Access Compliance Report Public Rights-of-Way (Curb Ramps)

Main Street: WOODLAWN_AVE		Cross Street: SKYLINE_DR		Location:	NW
ADA ID: RPAT211012132342	Ramp Type: Type 6 - Directional 1	Initial Pass/Fail: Fail	Overall Compliance: No	Severity Score:	2
Codes/Mitigation Info/Possible Solution			Field Measurements/Component Compliance

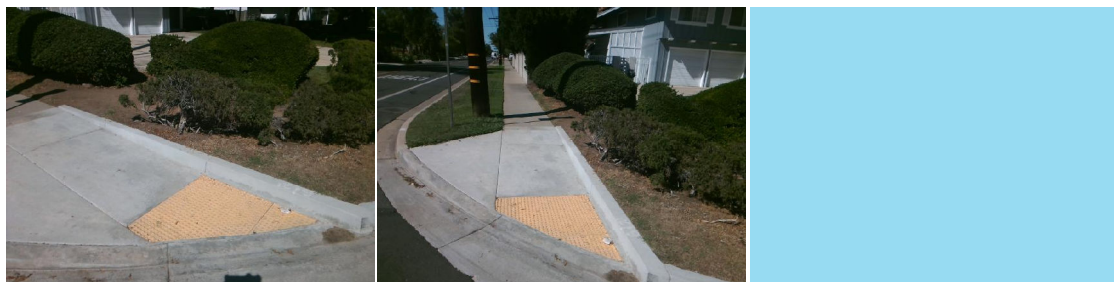
R304.5.3, STD 1115

Remove & Replace Entire Ramp.
